CCK-2874.00-3-25

New Environmental Quality Management Center

ADDENDUM #3

ADDENDUM #3

9 ROOF DETAIL @ BRICK TO STUD
 A-7.02 3" = 1'-0"

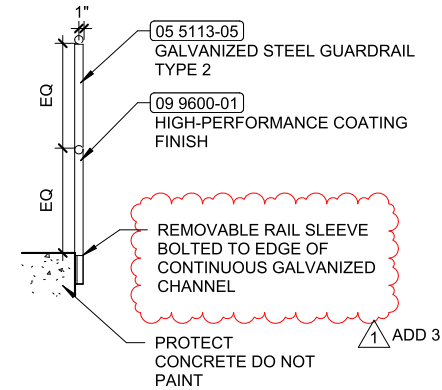
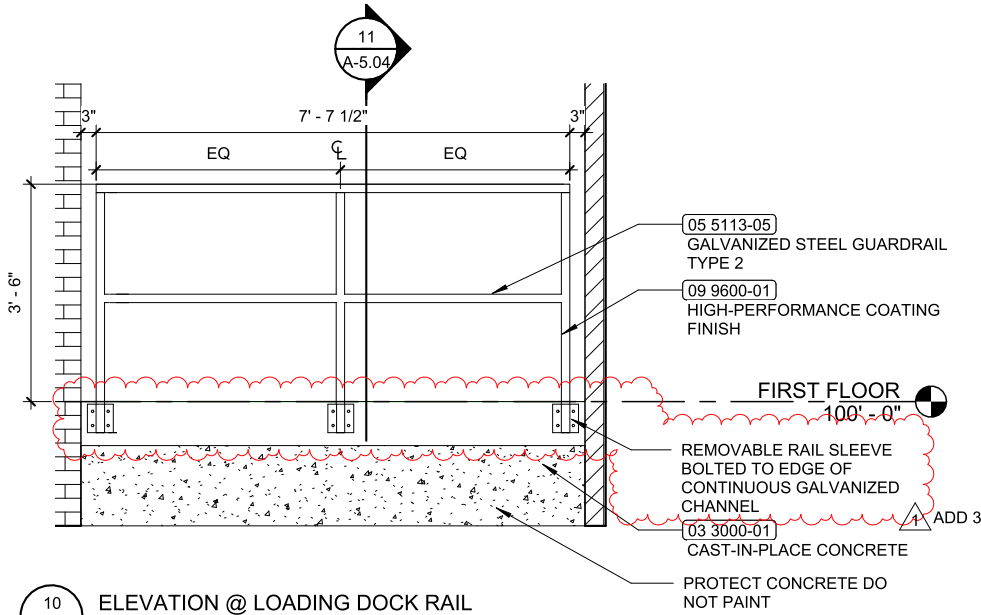
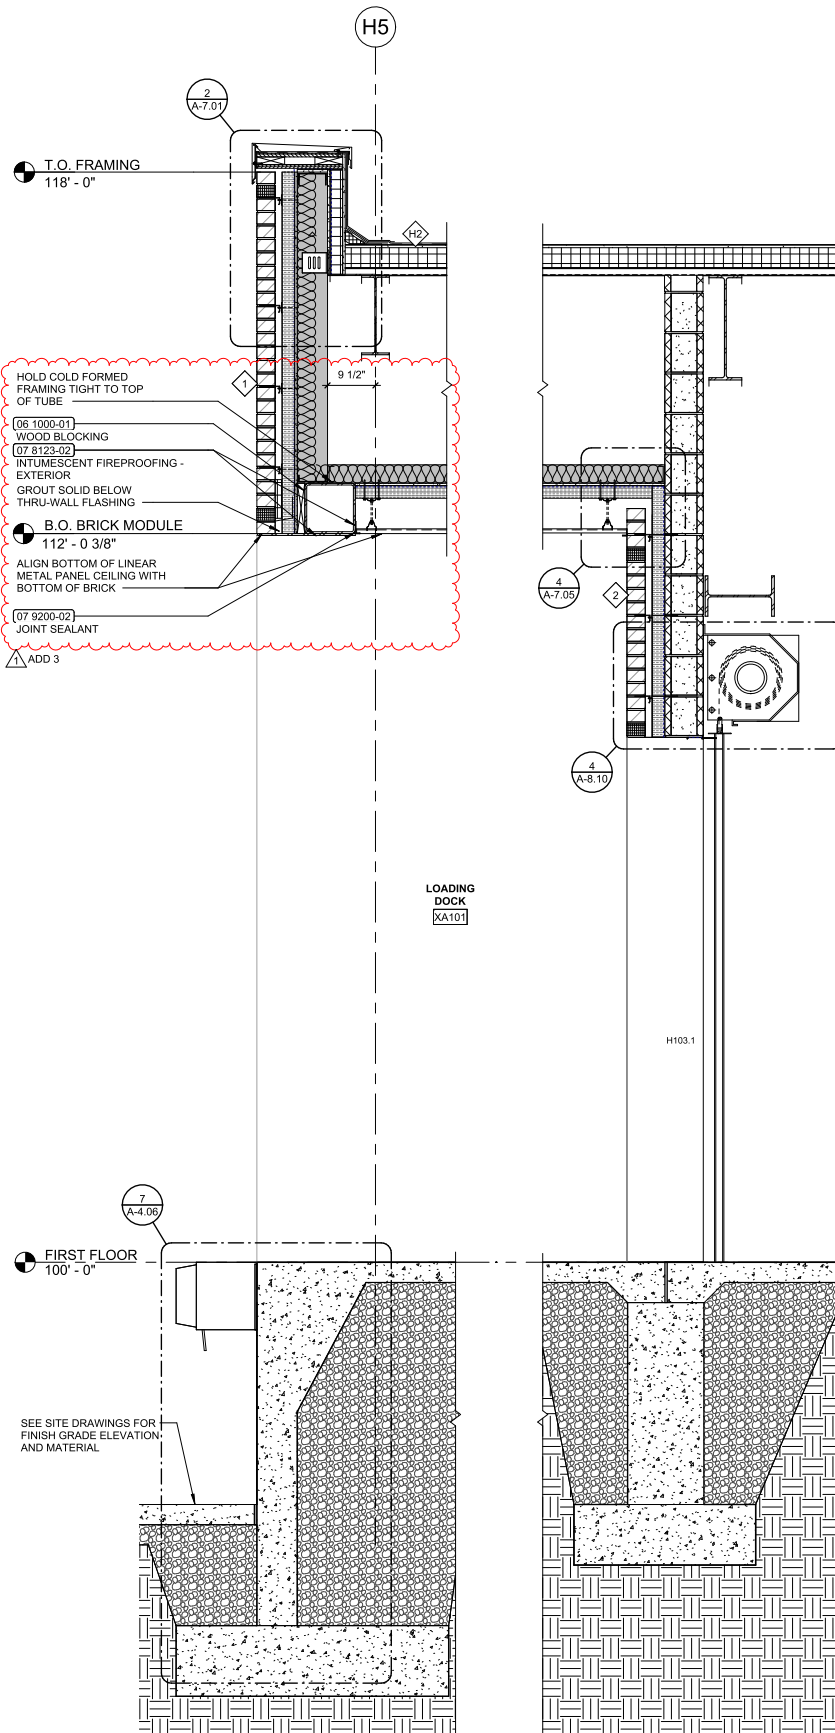
5. **Reference wall section 1 on sheet A-4.05, detail 9/A-7.02 and attached ADD 03 A-0.1 for revised detail 9/A-7.02 “Roof Detail @ Brick to Stud”:** Note the Continuous L4x3x5/16 angle and cold-formed connection clip shown on wall section 1/A-4.05 “Wall Section @ Mechanical Stair” has been added in the enlarged detail 9/A-7.02.

FIRST FLOOR LIGHTING PLAN
E2.0 1/8" = 1'-0"

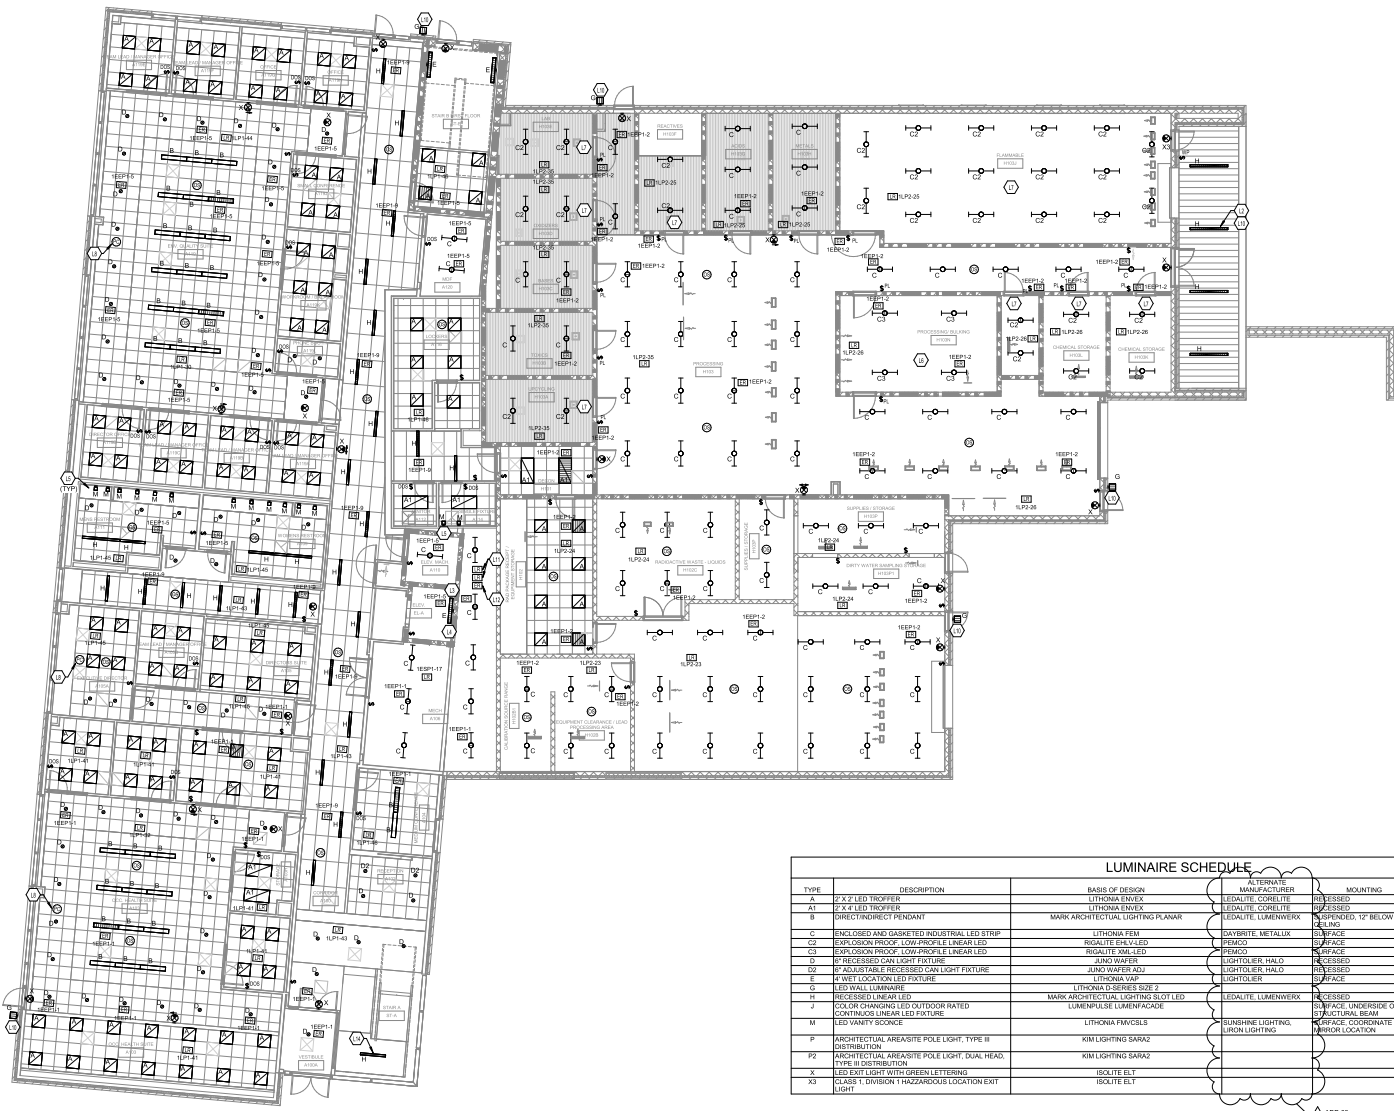
- Item #6 Refer attached sheet E2.0
A. Added alternate manufacturers to luminaire schedule.
- Item #7 Refer to attached sheets E3.0 and E3.2
A. Added note E28 to clarify power for wall mounted displays.

1 ENLARGED MDF PLAN
E5.0 1/2" = 1'-0"

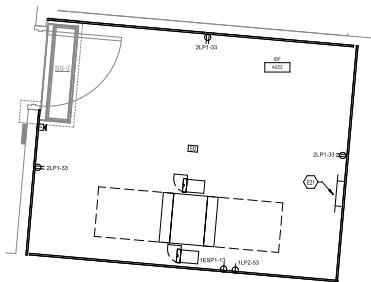
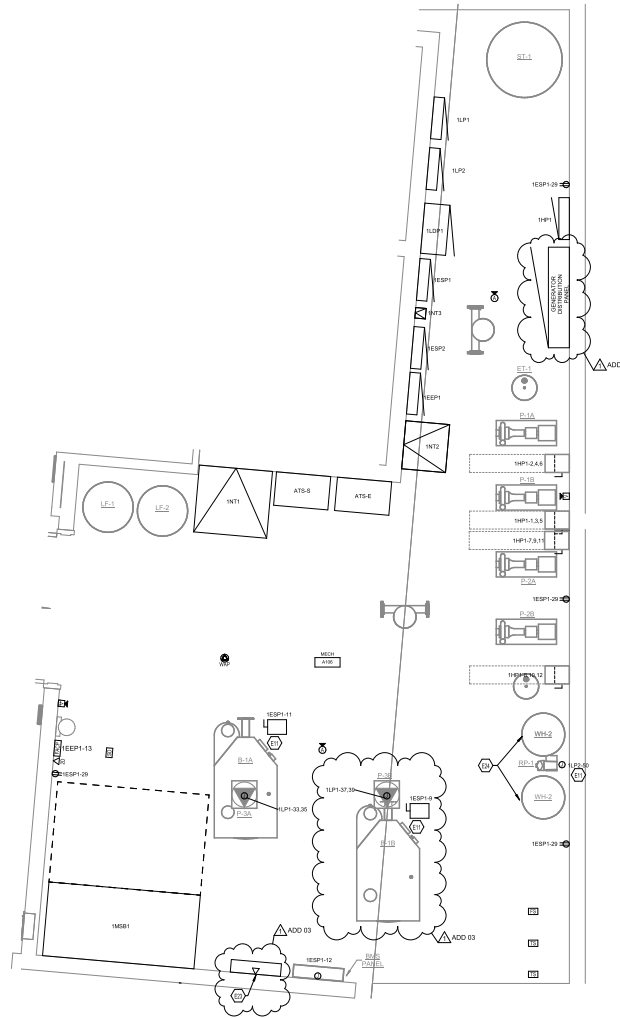
- Item #8 Refer to attached sheet E5.0
A. Deleted transformer 1NT3 on plan south wall as it is no longer needed.
B. Added new CT cabinet in previous location of 1NT3 and relocated data drop for metering of switchgear. Edited note E23 to reflect this.

C. Boiler B-1B and associated disconnect have moved slightly.
D. Adjusted dimensions of Generator Distribution Panel to match selected unit.
- Item #9 Refer to attached sheet E6.3

TRENCH DRAIN VALVE ACUTATOR CONTROL PANEL
8 SCALE: NONE

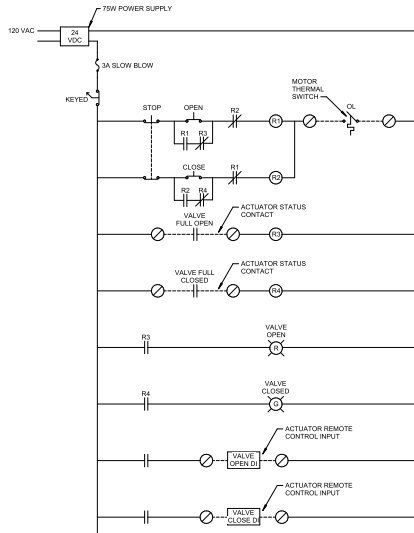
A. Added details 7 and 8 for control of trench valve actuator.
- Item #10 Refer to attached sheet E7.0
A. Changed wire and breaker size of P-1A and P-1B due to change in pump horsepower.

EU101

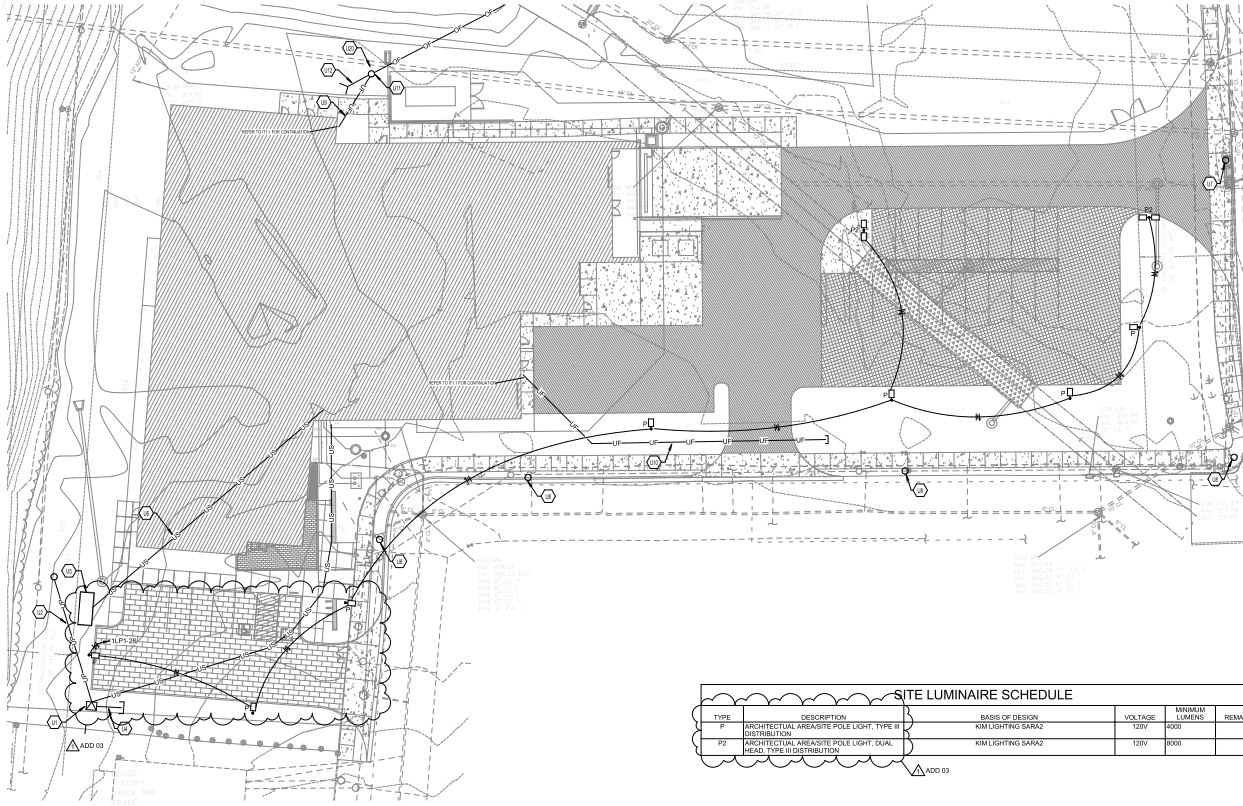
- Item #11 Refer to attached sheet EU101
A. Changed location of generator and some parking lot light fixtures.
B. Called out distribution type in Site Luminaire Schedule.

1 FIRST FLOOR AIR DISTRIBUTION PLAN
1/8" = 1'0"

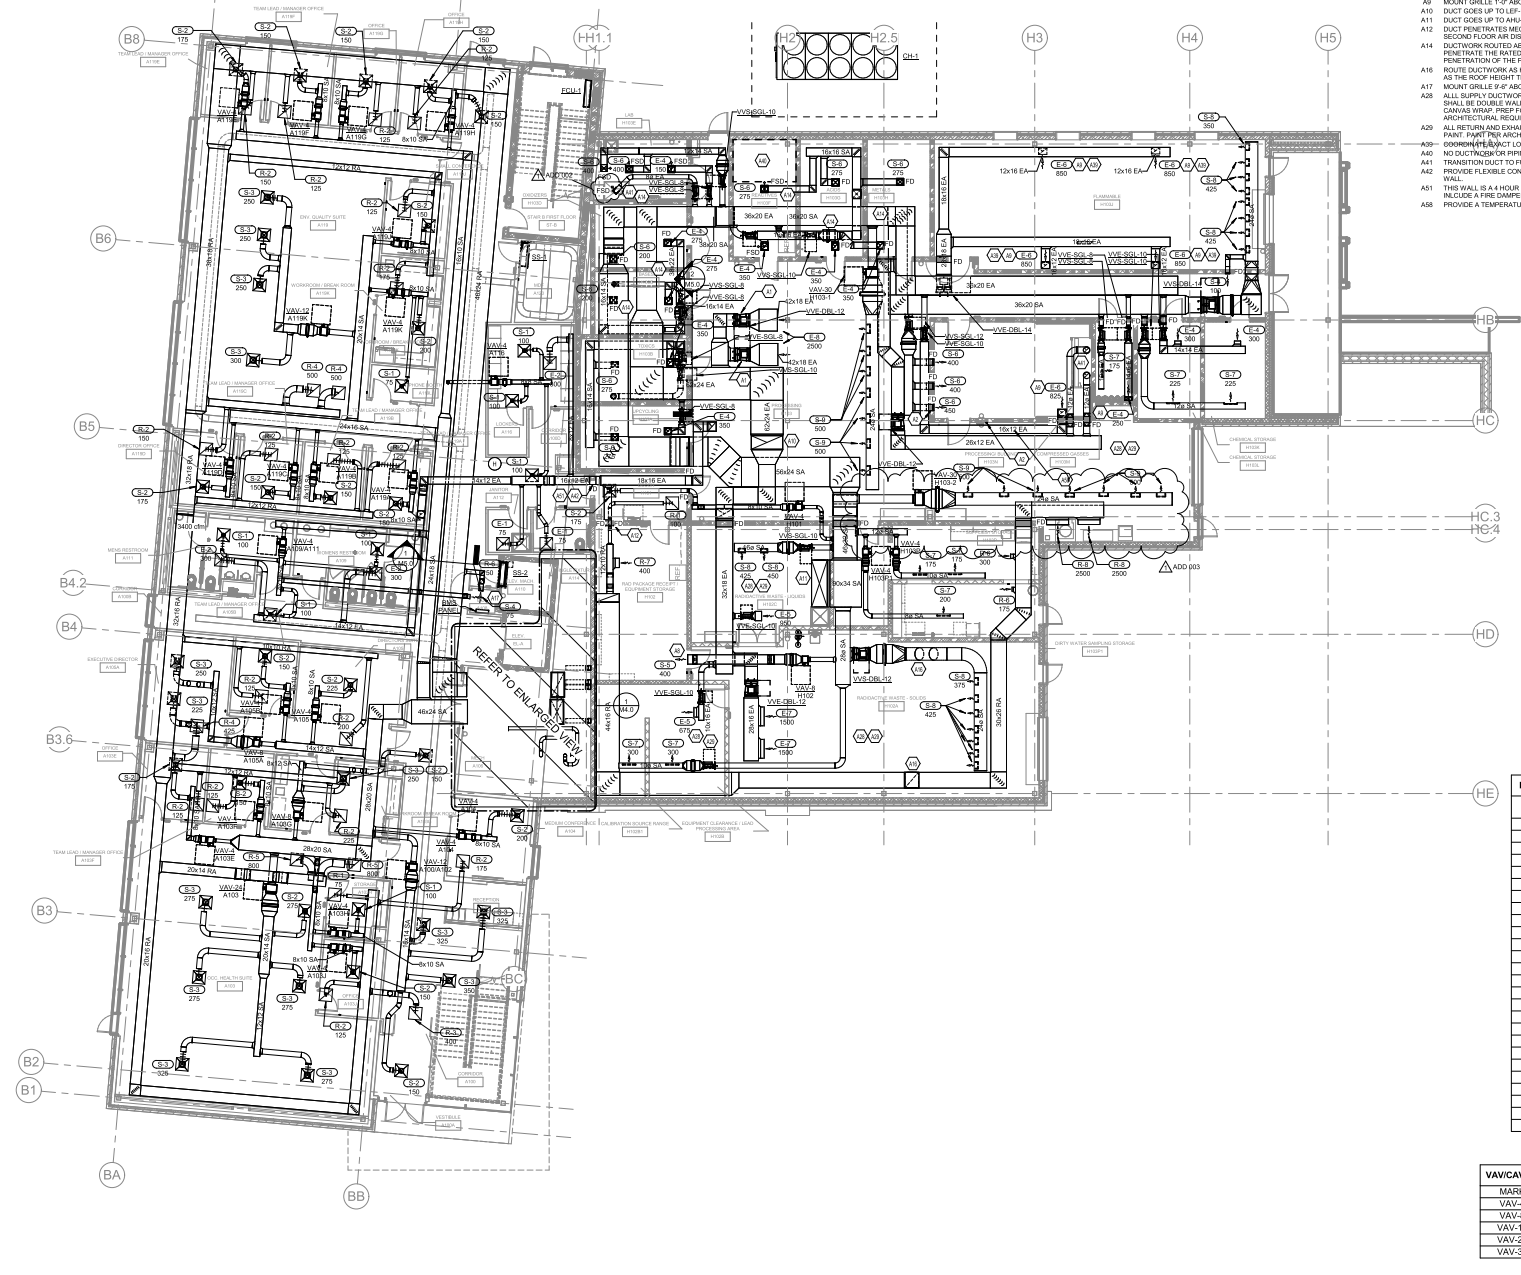
- Item #3 Refer to attached sheet M2.0
A. Reroute the 30x26 RA duct. Move the SA duct, VAV, and reheat coil plan north.
- Item #4 Refer to sheet M6.0
A. Refer to the Chilled Water piping schematic on M6.0. The chilled water bypass minimum flow rate is 200 gpm. Confirm the minim flow rate with the provided chiller manufacturer. Pipe size shall be 4 inch minimum.
